Subject: Nuclear Energy Institute Comments on NRC Proposed Rule, "Enhancements to Emergency Preparedness Regulations," 74 Fed. Reg. 23,254 (May 18, 2009) (Docket ID NRC-2008-0122)

Project Number: 689

Subject: Nuclear Energy Institute Comments on NRC Proposed Rule, "Enhancements to Emergency Preparedness Regulations," 74 Fed. Reg. 23,254 (May 18, 2009) (Docket ID NRC-2008-0122)

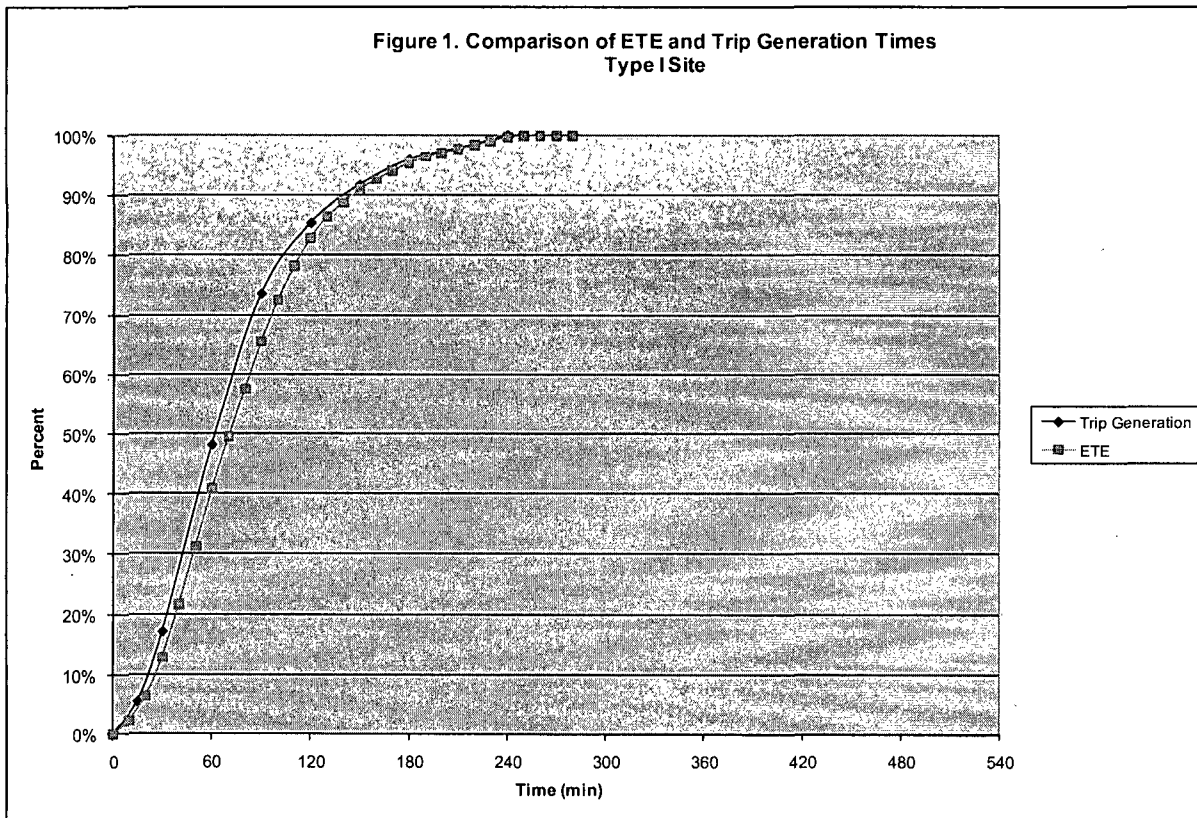
Type I: These sites have ETEs that reflect a population's mobilization time distribution and are independent of population. These are low-population sites with an adequate highway system. Congestion (LOS F) during an evacuation is minimal or limited in temporal and spatial extent. Reasonable, expected increases in population over the next decade would not materially increase ETE due to the reserve (i.e. unused) highway capacity now available (see Figure 1). Note that the ETE distribution closely tracks the mobilization time distribution; the small separation between these curves represents the average evacuation trip travel time of mostly free-flowing traffic.

To demonstrate the insensitivity of ETE with respect to population growth for such sites, the population within an actual Type 1 EPZ was increased by 25 percent and the evacuation model PC-DYNEV was executed to calculate the resulting ETE. The resulting increase in ETE over the entire EPZ, at the 50th, 90th, 95th and 100th population percentiles, was a minimal 5 minutes.

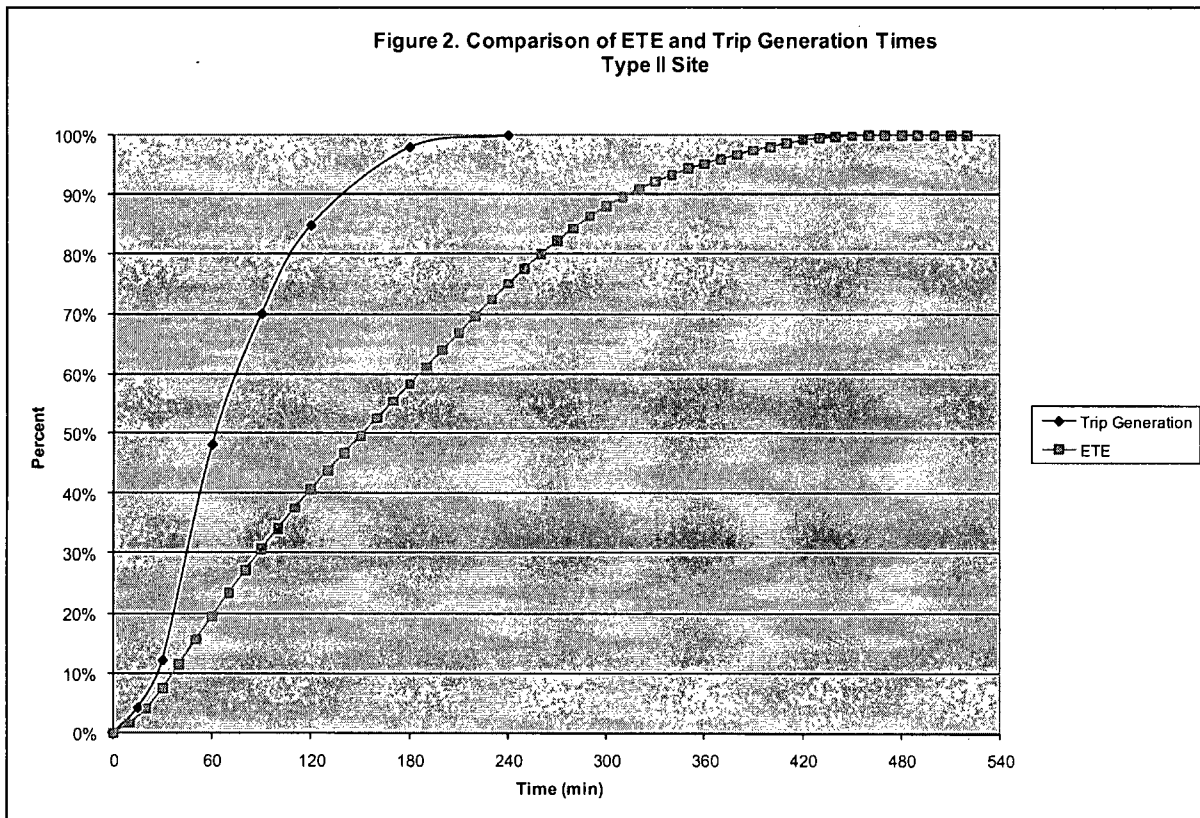
Type II: These sites have ETEs which reflect extensive congested traffic conditions (LOS F) on the evacuation highway network and are largely independent of the mobilization time distribution (see Figure 2). Changes in population will most likely change ETE at least proportionately, given no change in infrastructure. A material change in infrastructure, with or without population change, can also change ETE.

Note that the ETE distribution curve of Figure 2 separates from the mobilization time distribution curve almost immediately, indicating that congestion develops rapidly and remains the controlling factor affecting ETE.

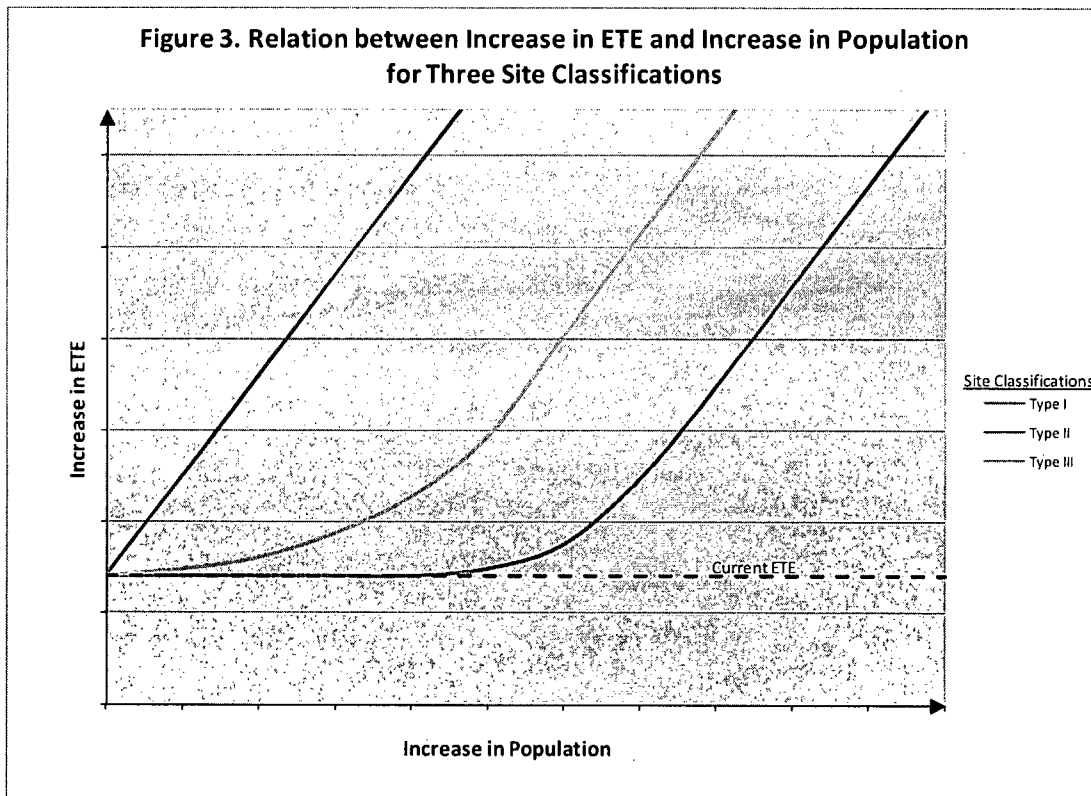
Another representation of the three site types presented above appears in Figure 3, which is a hypothetical sketch for illustration. Here, the graphical depictions show...

- The near-term insensitivity of ETE to increases in population at Type I sites¹.
- The immediate pronounced increase in ETE with an increase in population for Type II sites
- The possible near-term increase in ETE due to increasing population, for Type III sites that might transition to Type II.

For clarity, Figure 3 does not address a decrease in population:
